SITE PLAN & ARCHITECTURAL
COMMISSION
AGENDA
SEPTEMBER 6, 2019

COMMISSION REPORT

Project Crater Corners
Applicant: MC Property Holdings LLC; Agent: Oregon Architecture Inc.

File no. AC-19-058

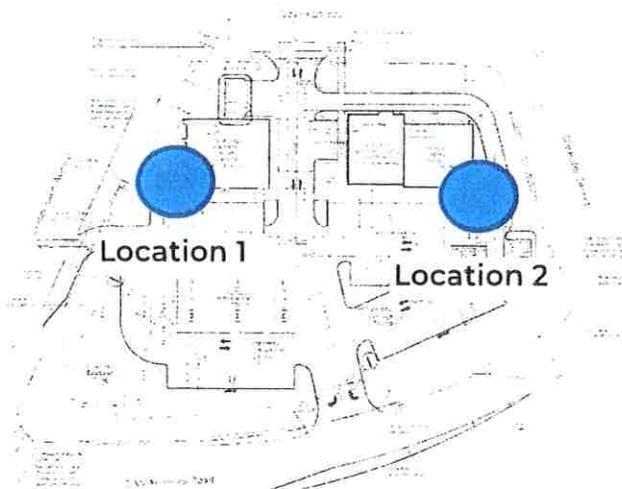
Per the site plan, the applicant proposes to install 47 vehicular spaces, including three Disabled Person Vehicular Spaces and one Compact Car parking stall.

Bicycle parking is proposed at two separate locations: Two spaces are shown west of the convenience store building on the Crater Lake Avenue side (Location 1) with another four spaces shown to the east of the proposed retail structure along Oleander Street (Location 2). Neither bicycle parking location meets current locational standards per the Medford Land Development Code. MLDC 10.749 - Location of Bicycle

Parking Facilities states that, 'Required bicycle parking facilities shall be located on-site in well-lighted, secure locations within 50 feet of well-used entrances and not farther from the entrance than the closest automobile parking space. Bicycle parking shall have direct access to both the public right-of-way and to a main entrance of the principal use.' Both locations are within 50 feet of an entrance but are placed farther

away from the entrance than the closest automobile parking space. Additionally, Location 2 lacks direct access to the public right-of-way. A condition of approval to provide bike parking meeting the standards of MLDC 10.749 has been included.

After discussion, the Commission decided to strike condition of approval #3. The bike parking distance requirements were recently amended and it is the applicant's intention to meet the new requirements.

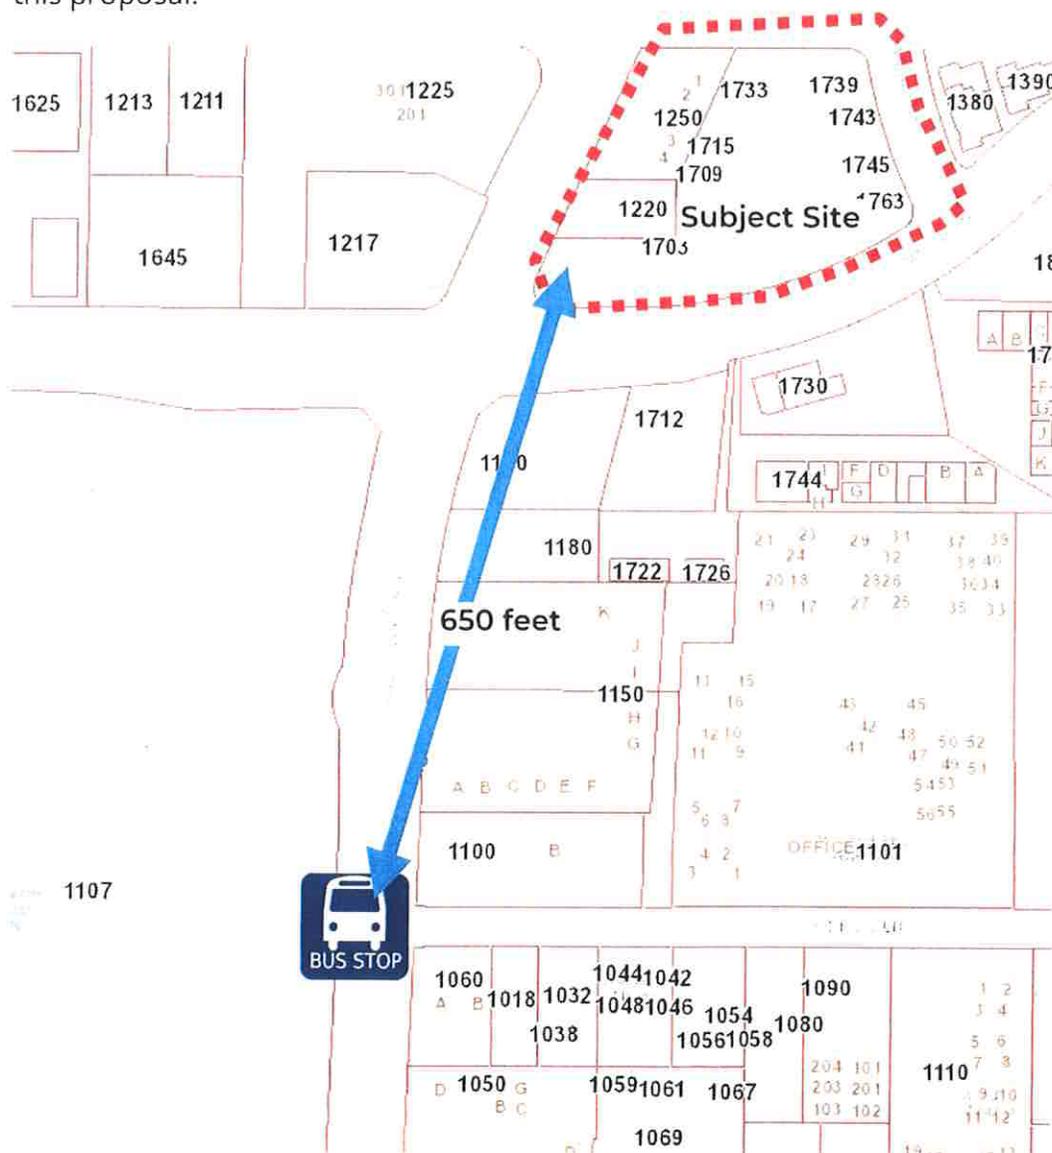
The submitted landscape plan (Exhibit K) shows landscaping along all four street frontages and within the parking lot. The Commission can find that the submitted landscape plan meets all of the landscaping requirements per MLDC 10.797 and 10.746(3).

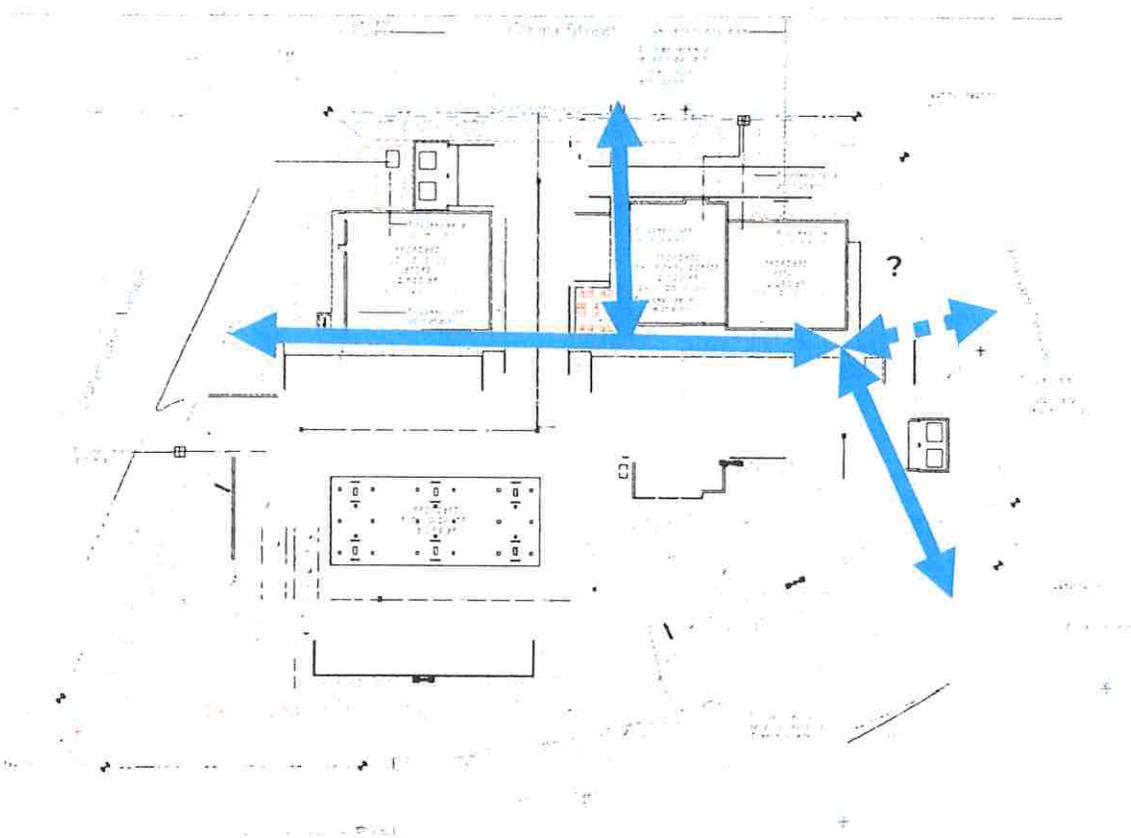
As can be seen on the submitted Site Plan below, pedestrian connectivity is proposed between the structures and to the Crater Lake Avenue and Covina Street rights-of-way. As the McAndrews Road street frontage exceeds 300 feet, two pedestrian walkway connections are required between the development and the right-of-way. One pedestrian connection is proposed. No pedestrian walkway is shown along the Oleander Street right-of-way.

The applicant stated in his findings *that the grade to Oleander Street is too steep to create a reasonable access without a stair access and that it will be more convenient for pedestrians to walk down Covina Street to enter the site mid-block. Per the applicant, the same is true for pedestrians accessing the site from the east via McAndrews.* In the additional findings, as provided by the applicant on August 8, 2019 (Exhibit T), the applicant again stated that *there is a vertical difference of*

approximately 4 feet from the sidewalk in front of the Starbucks and the sidewalk along Oleander Street and that there is not enough room to get a connection in within this area, nor is there likely any pedestrians that would be served by this connection that would not find any of the other pedestrian connections equally accessible to either building.

Staff agrees with the applicant's findings that routing pedestrians through an active gas station is unsafe and supports the proposed design shown on the revised site plan providing pedestrian access from E McAndrews Road.

However, upon conducting a site visit, and as can be seen on the photos below, staff disagrees with the applicant's findings that existing site conditions prevent a pedestrian walkway connection from the Oleander Street right-of-way to the site and, therefore, a condition of approval to provide a pedestrian connection to Oleander Street as required per MLDC 10.773 through 10.775 has been added.

The Commission decided that if the applicant can demonstrate that the alternate route works under MLDC 10.776, then a pedestrian connection to Oleander Street will not be needed.
